Re: Blue Jeans Golf (Golf Ranch) Foundation Discrepancy Response

PMA Engineering Project: P23145

# BLUE JEANS GOLF FOUNDATION MODIFICATION DRAWINGS

# INTERIOR FOOTING MODIFICATION **BLUE JEANS GOLF**

EXISTING INTERIOR FOOTING

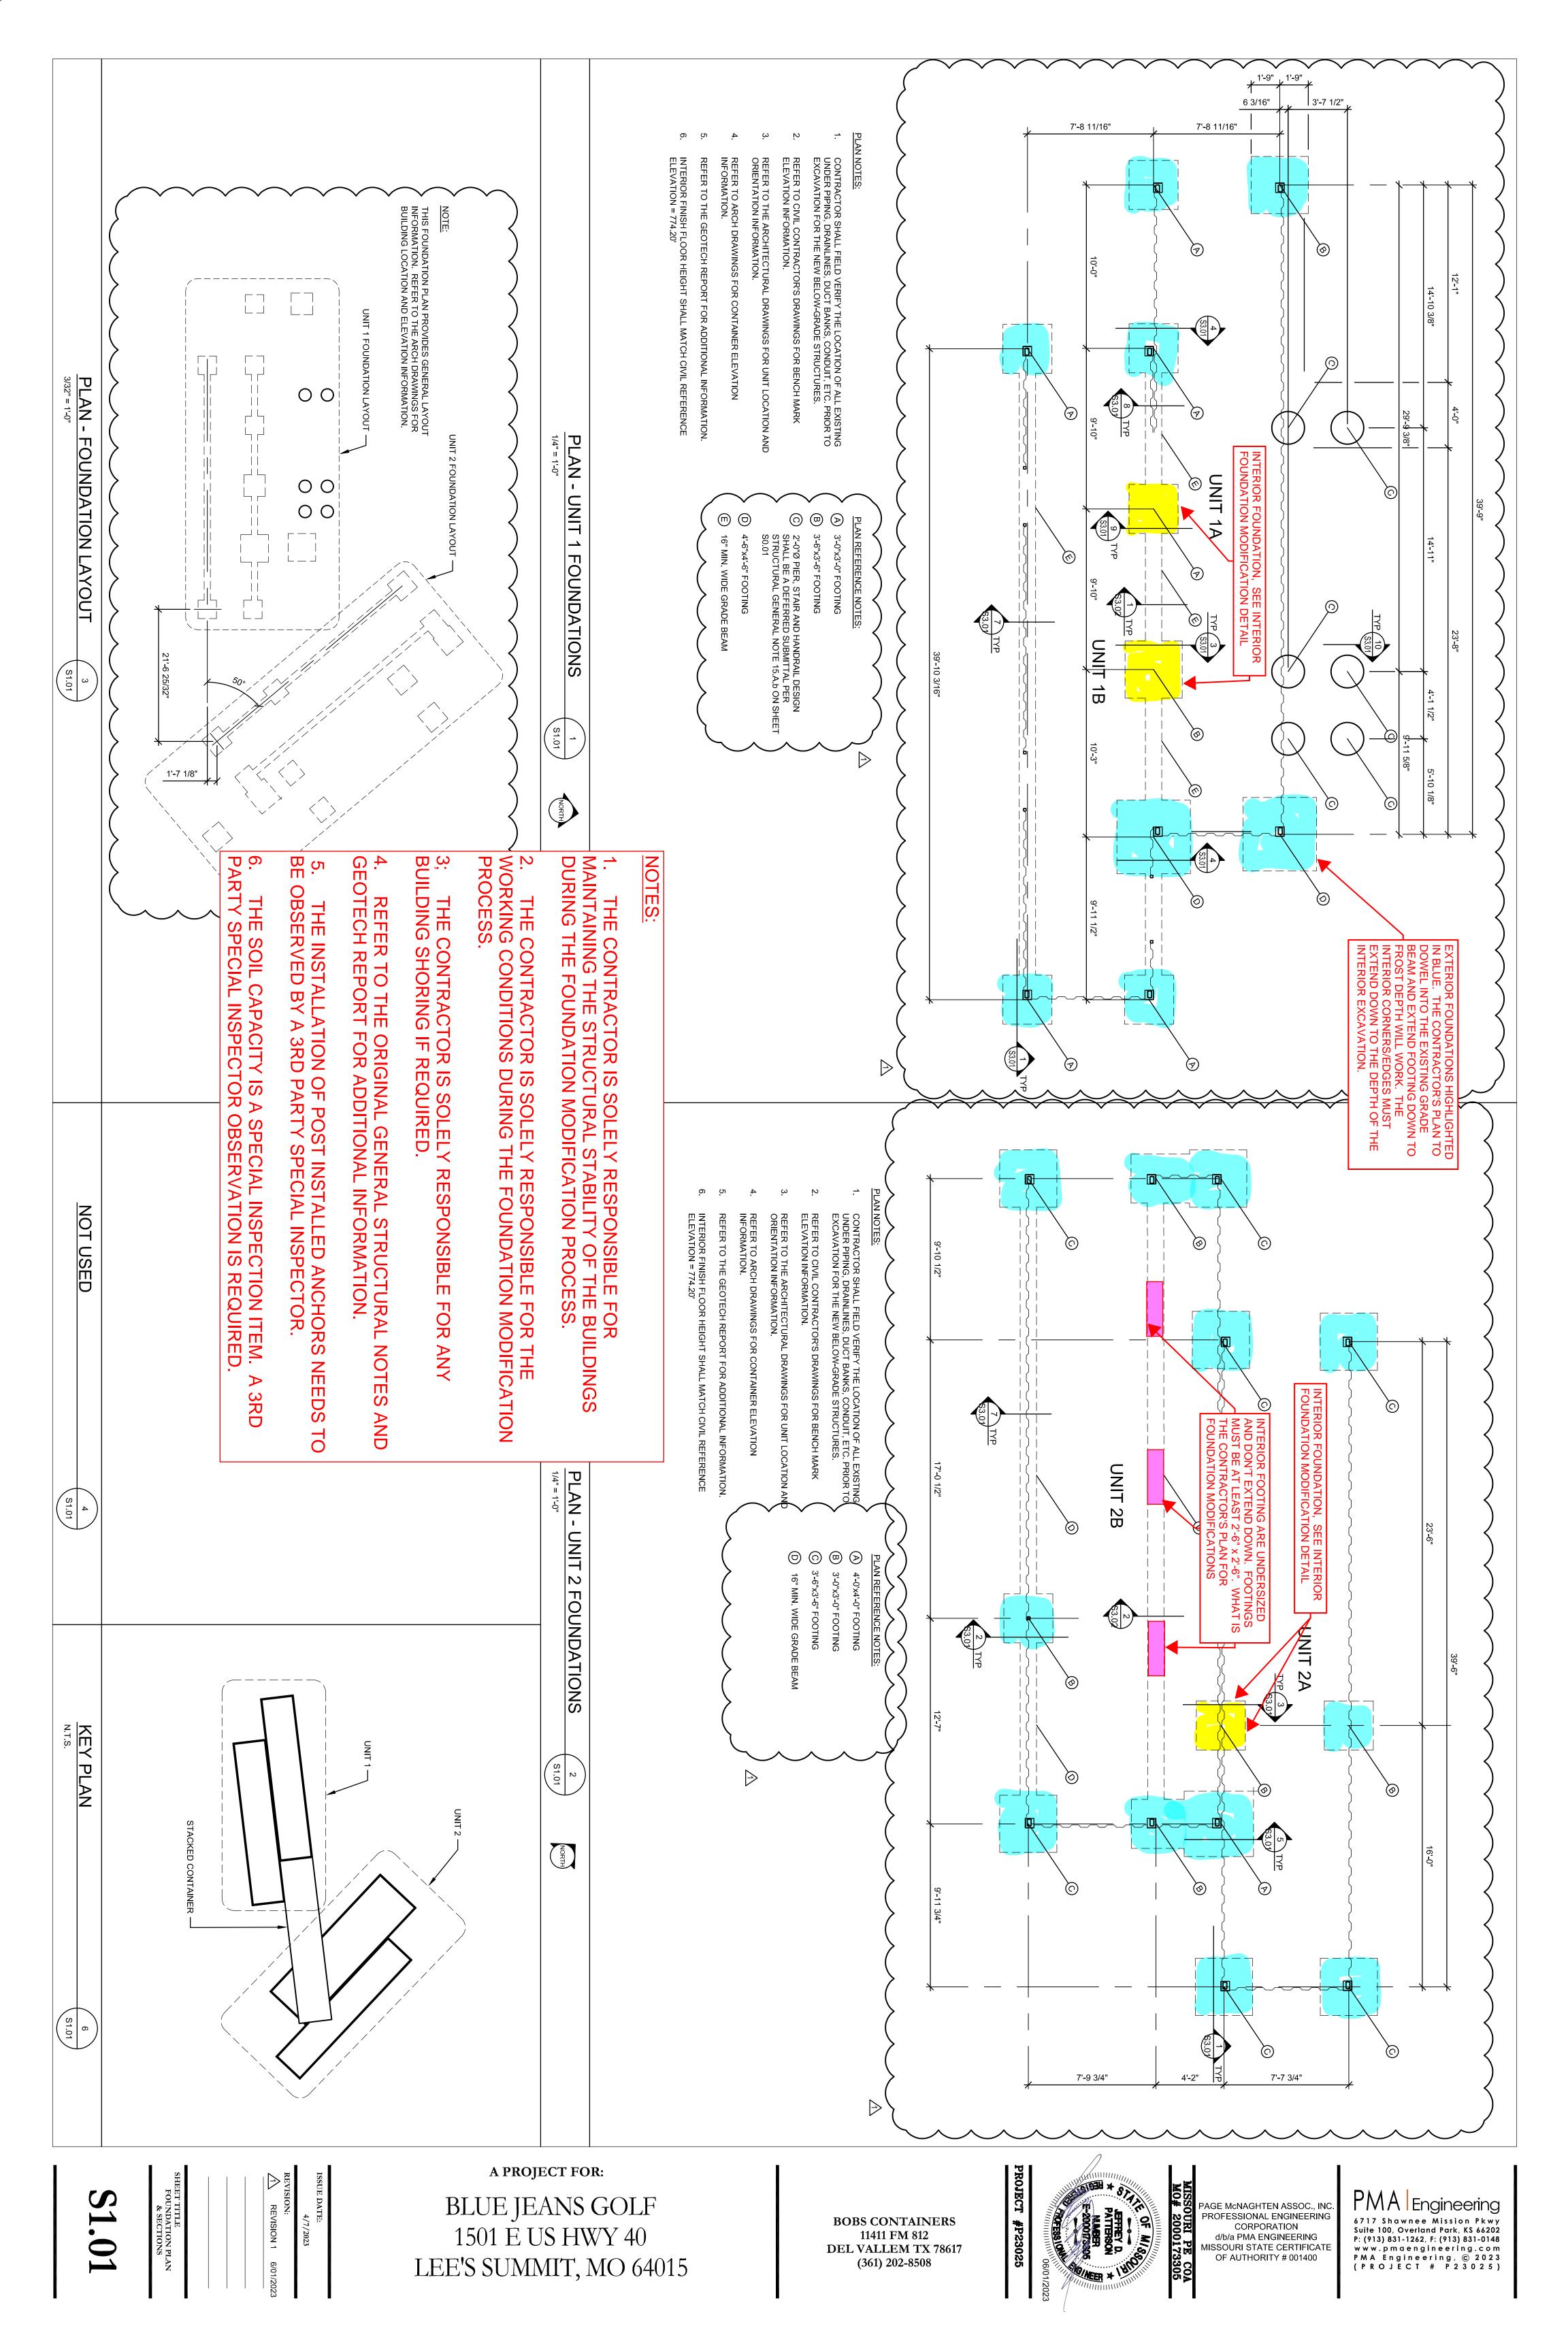
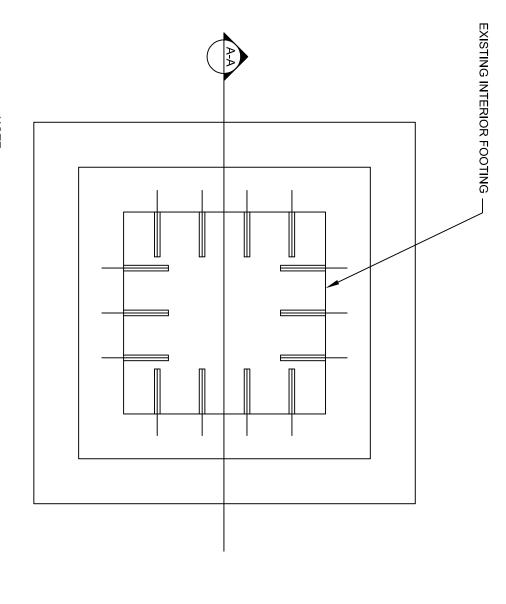
36" - IF EXISTING EXCAVATION IS DEEPER, EXTEND FOOTING TO EXCAVATION DEPTH B.O. CONC ELEV T.O. CONC ELEV #4 HOOKED BAR, SET WITH HILTI HIT HY 200, 8" MIN EMBEDMENT, SPACED AT 8" O.C. X'-X" Δ 8" MIN (TYP) 7 #4 BAR CONT (TYP)

FOOTING MUST SET ON SOIL THAT HAS A MINIMUM OF AT LEAST 1500 PSF SOIL BEARING CAPACITY
